RANDOLPH @ DOTGER
2427 RANDOLPH ROAD, CHARLOTTE, NC 28207
CONSTRUCTION DOCUMENTS

PRELIMINARY PLANNED
MULTI-FAMILY SUBDIVISION
APPROVAL

**OVERALL
PROJECT PLAN**

**CONSTRUCTION
DOCUMENTS**

C-000

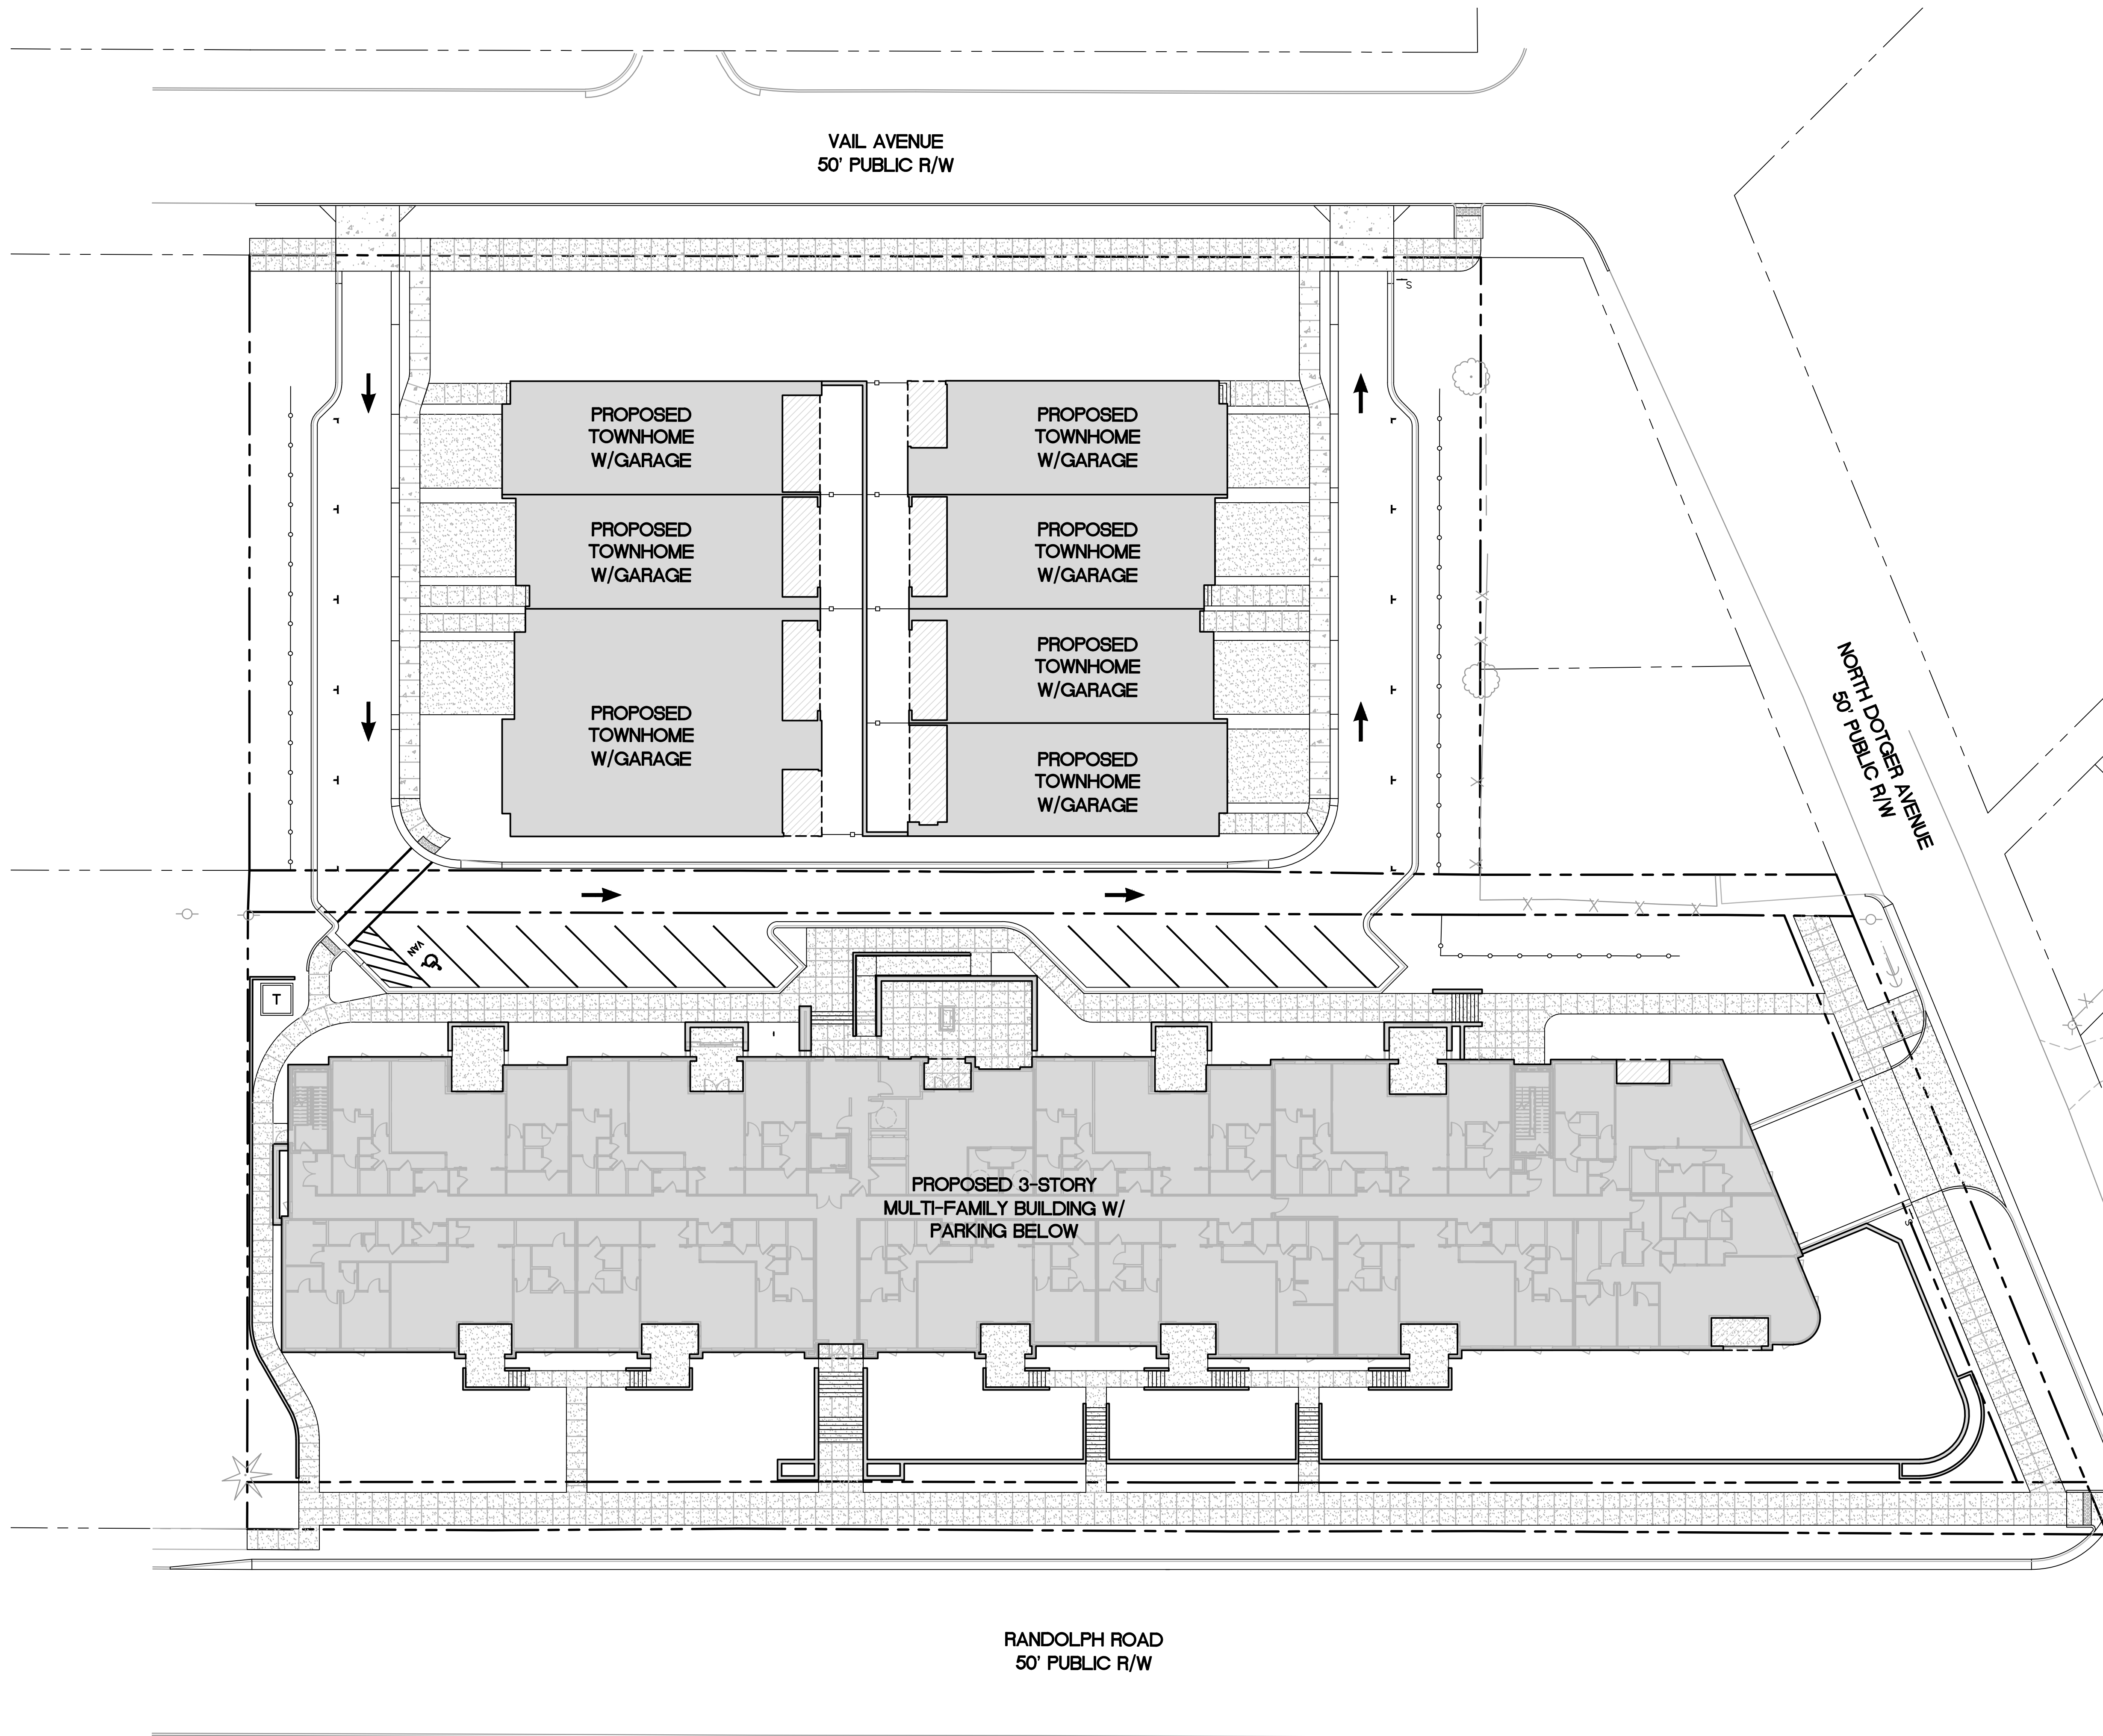
*Revision includes amending the number of units in the apartment building to 47 units and reducing the number of townhome units to 7. Per the approved plans, the allowable total density is 54 units. Additionally, the storm drainage (pipes and area drains) located in the townhouse backyards have been updated.
